# Product Change Notice (PCN)

PCN Number: **PCN-0450470R-01**

Product(s) Affected: **PJ-014D**

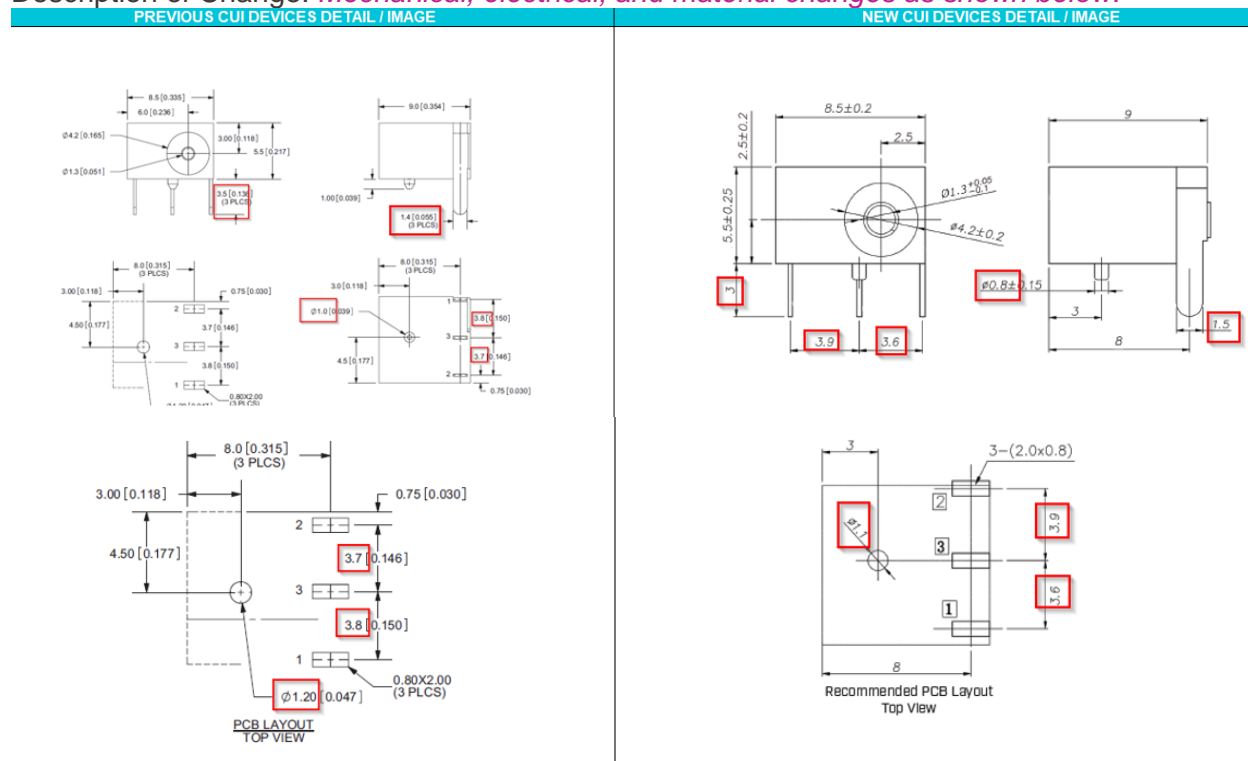
Description of Change: **Mechanical, electrical, and material changes as shown below:**

MATERIAL	PLATING
center pin	copper	nickel
terminal 1	brass	tin
terminal 2	copper alloy	tin
terminal 3	brass	tin
plastic	PBT

DESCRIPTION	MATERIAL	PLATING/COLOR
center pin	brass	silver
terminal 1	brass t=0.30	silver
terminal 2	stainless steel t=0.25	silver
terminal 3	brass t=0.30	silver
housing	PA66 (UL94V-0)	black
